Urbantech File No. 06-233ph2

**Re: Response to 3rd Engineering Submission Comments
(in support of Draft Plan approval)
Orangeville Highlands Phase 2
Town File No.: 51/10 & OPZ 5/10**

RE: ORANGEVILLE HIGHLANDS – TOWN COMMENT RESPONSE LETTER

TAC 2017 Sight Distance Hansen Boulevard & Street B Crossing Maneuver

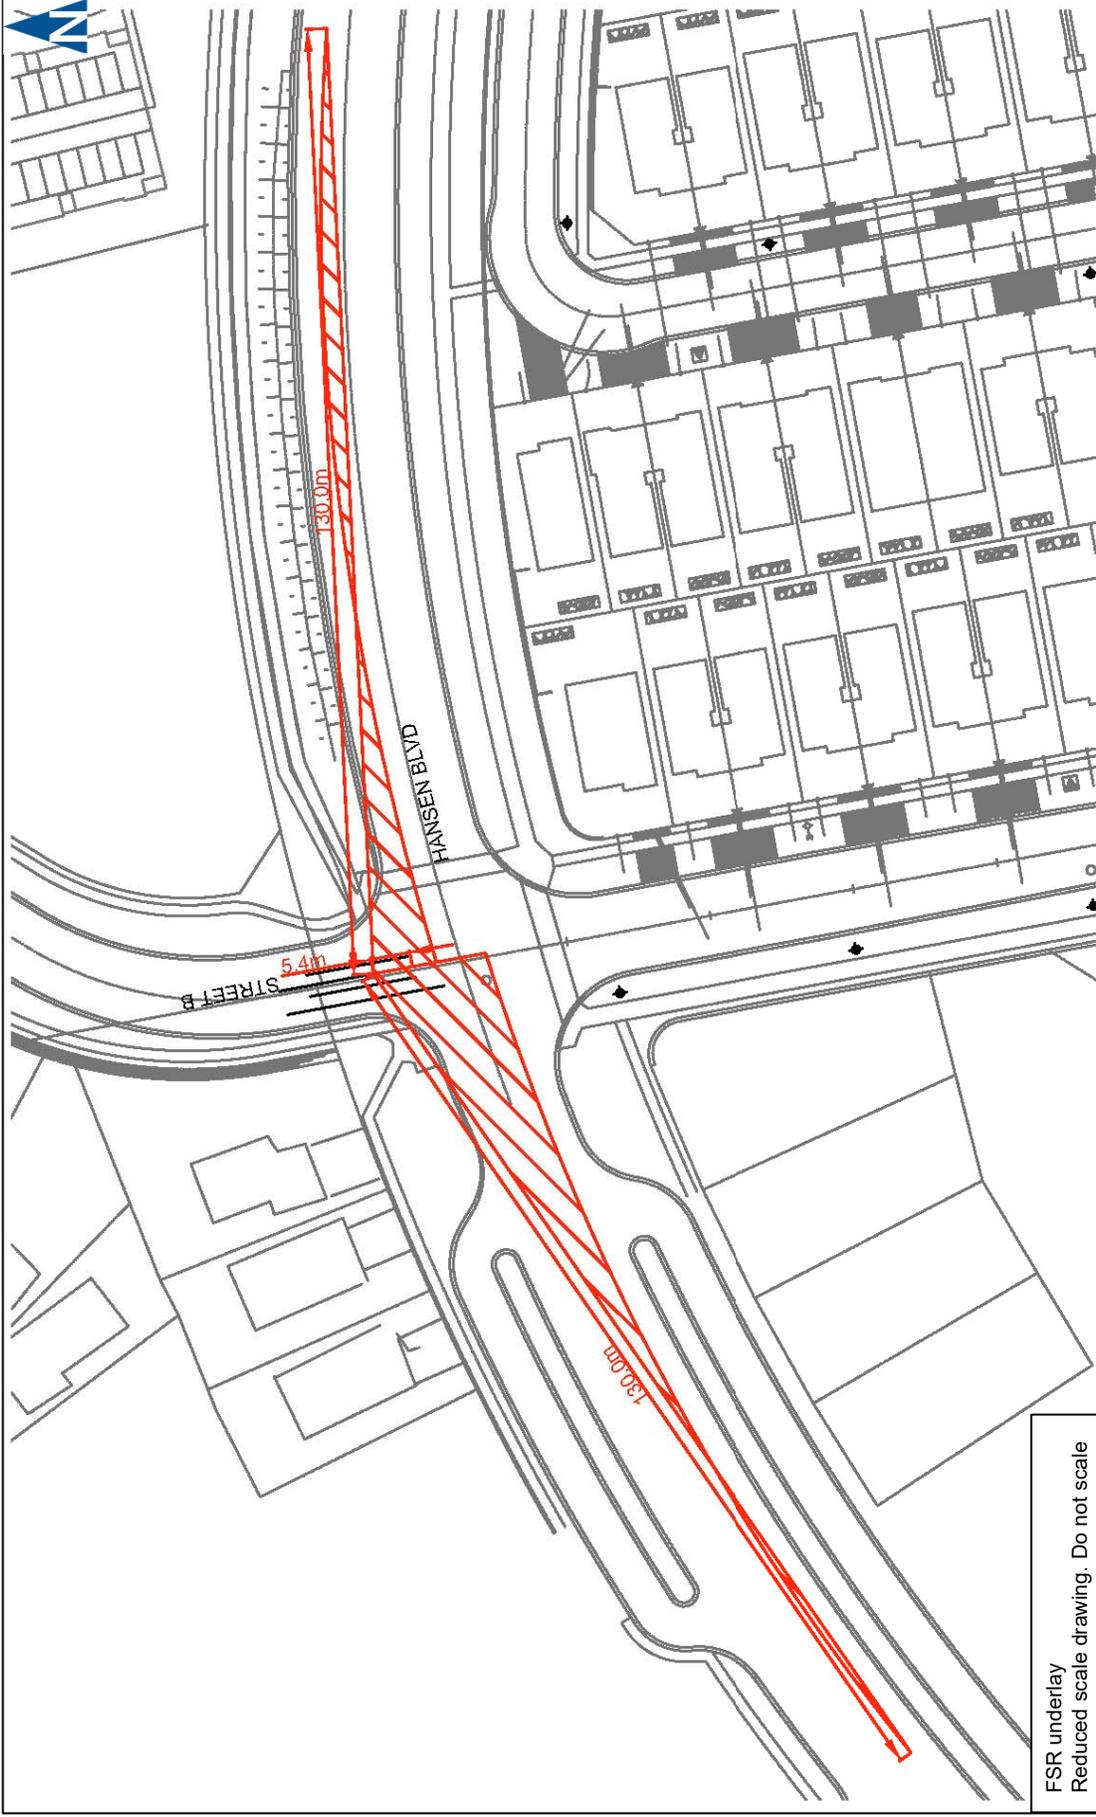
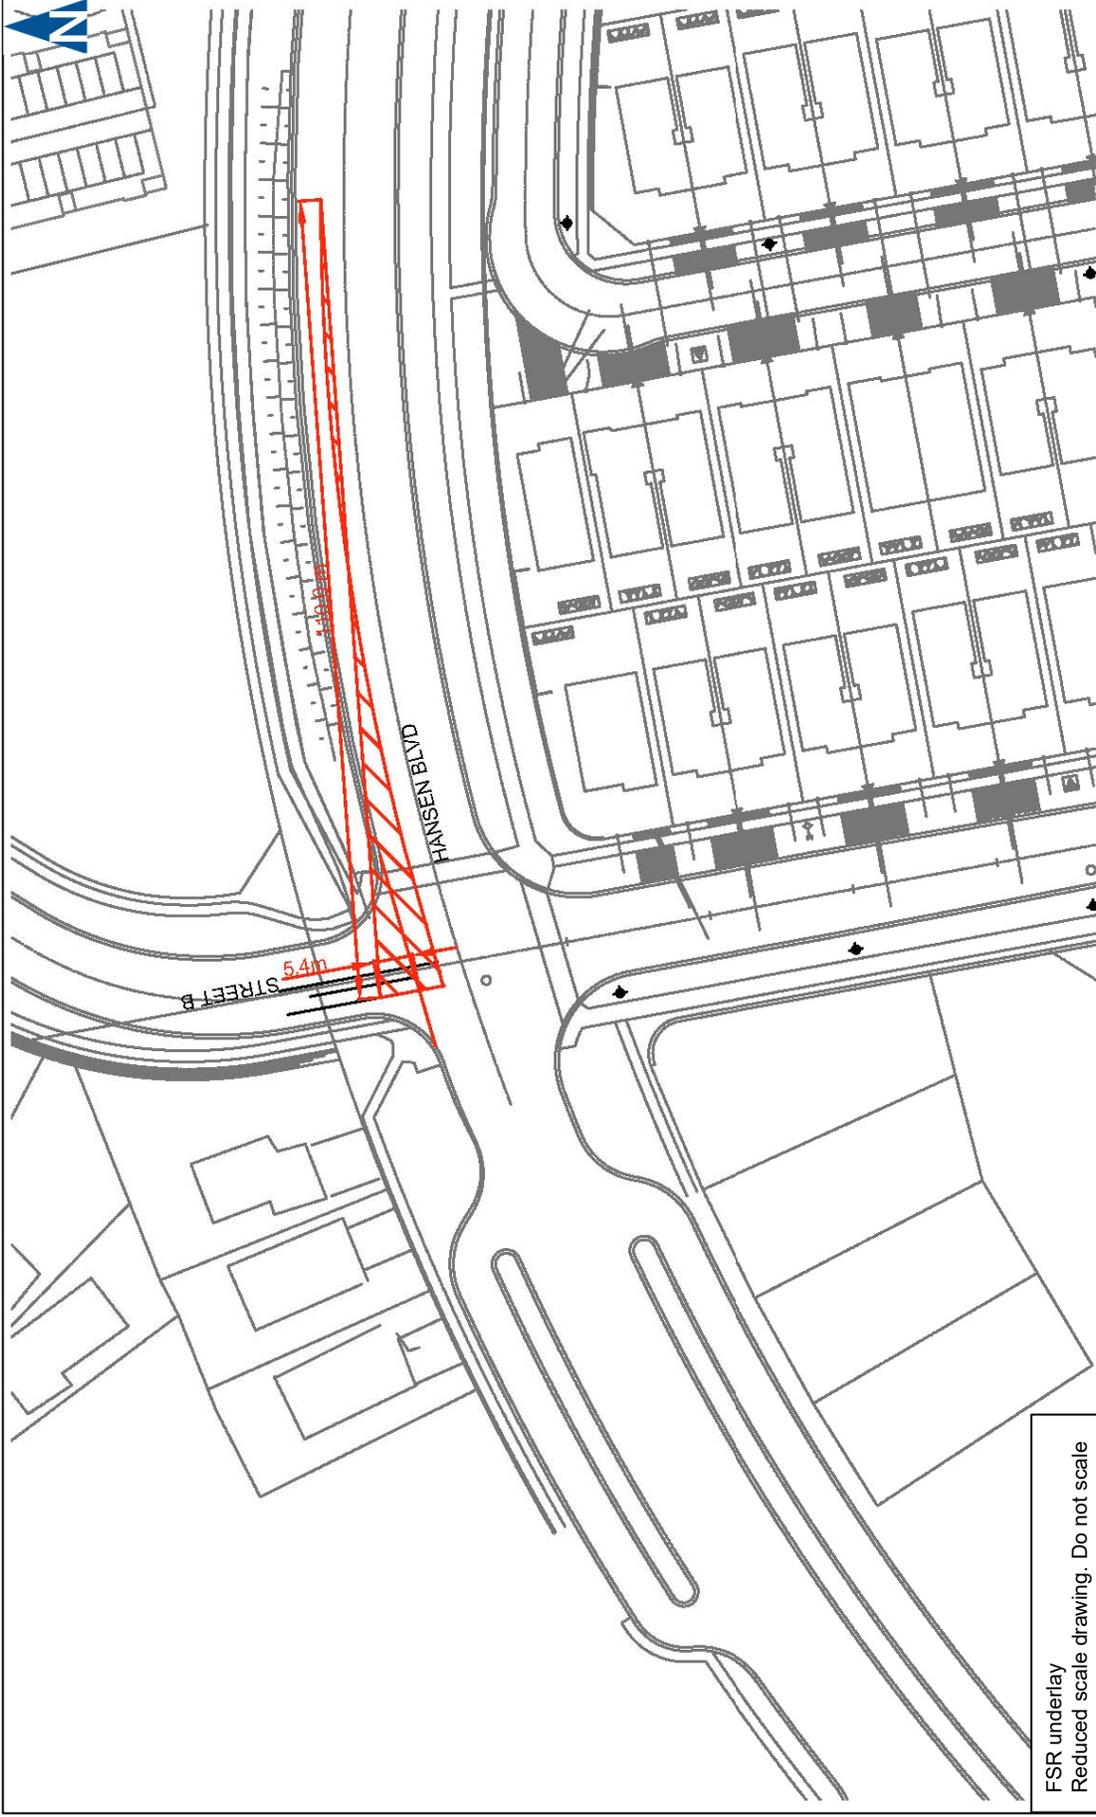
- Both intersections into the development will be signalized in accordance with the traffic impact study. The calculations for site line requirements have not been provided. Please provide the required calculations indicating that proper site distance and visibility triangle has been provided for stop controlled intersections. Refer to the TAC Manual Section 2.3.3.5, copy attached.

“Both intersections into the development will be signalized in accordance with the traffic impact study. The calculations for site line requirements have not been provided. Please provide the required calculations indicating that proper site distance and visibility triangle has been provided for stop controlled intersections. Refer to the TAC Manual Section 2.3.3.5, copy attached.”

Please refer to **Attachment 4** for a detailed sight-line analysis prepared by Paradigm.

The Transportation Association of Canada (TAC) Geometric Design Guide for Canadian Roads referred to by the Town is the September 1999 version. The TAC Geometric Design Guide for Canadian Roads June 2017 manual is the current version and follows best practices. Based on the TAC 2017 manual¹, the following sight distance requirements apply for a design speed of 10 km/h over the posted speed limit (60 km/h):

Attachment A contains the sight triangles for Street A and Street B based on TAC Geometric Design Guide for Canadian Roads June 2017.

The sight triangles for Street A and Street B are contained within the existing Hansen Boulevard right-of-way. The proposed daylight triangles to the Street A and Street B approaches are satisfactory. No changes to the block layout are recommended.

TYPICAL SECTION - NOT FOR CONSTRUCTION

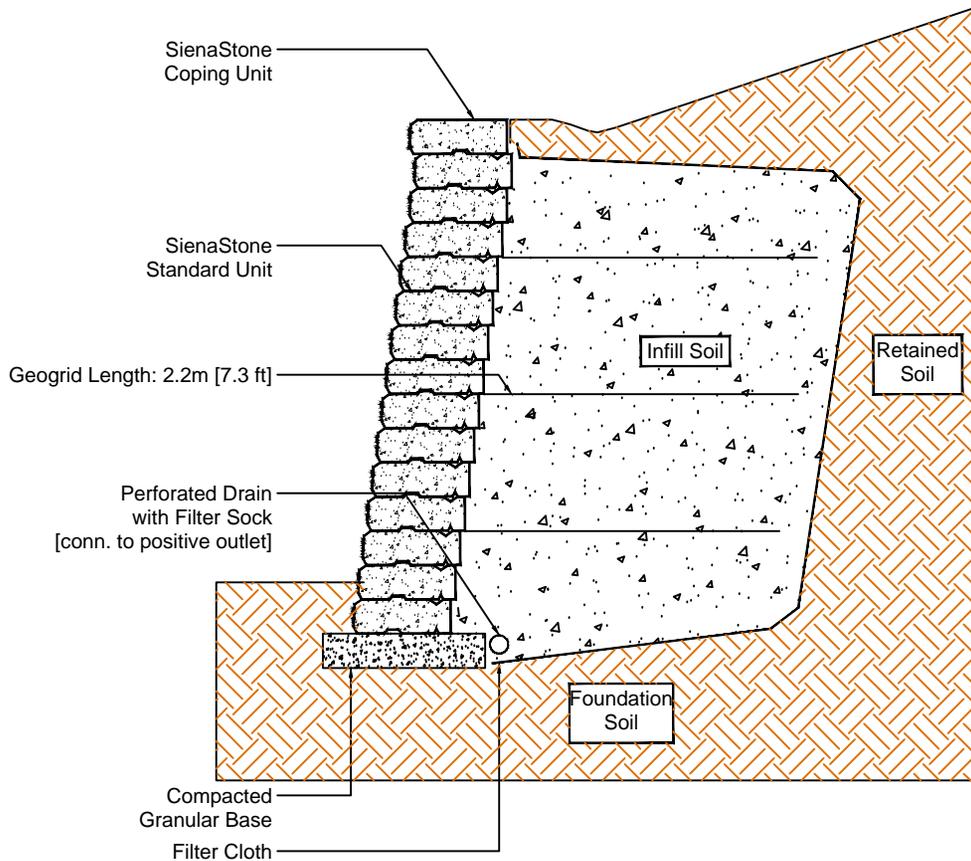
- In addition to Bullet 3 above, the applicant is proposing to construct a retaining wall to overcome the physical constraints and changing elevations on the west side of the intersection abutting the existing properties. Include the retaining wall and a brief summary of how that structure will be constructed against the existing residences relative to the right-of-way. We appreciate that these are construction details that will be addressed during the design review stage of the development. However, there are some concerns as it relates to the constructability of all required features in the amount of ROW being proposed. All other retaining walls being proposed are to be located on private property.

As the height of the wall varies to nearly 3m, drawings prepared by a licensed structural engineer will be required for approval and construction. However, to facilitate draft plan approval we have provided a conceptual design illustrating how the proposed wall could potentially fit within the 23.5m wide right-of-way plus adjacent 1.5m wide block adjacent to the existing property and be constructed without encroachment onto the adjacent properties. Refer to **Attachments 3 and 5** for details. Depending on the length of the geogrid (i.e. tiebacks) required, the face of the wall may need to be adjacent to the sidewalk (currently 0.2m of separation is shown which still allows a separation of 1.2m from the face of the sidewalk to the back-of-curb).

We generally agree that retaining walls, where required to support private development (i.e. medium density blocks) should be located on private property and confirm that further details will be provided at detailed design. However, we disagree that the retaining wall required to facilitate the norther trail connection Brucedale Boulevard should be on the private lot since the wall is only required due to the walkway's grading constraints, not the private lot's grading. Accordingly, the wall should be owned and maintained by the Town as part of their walkway block/trail system.
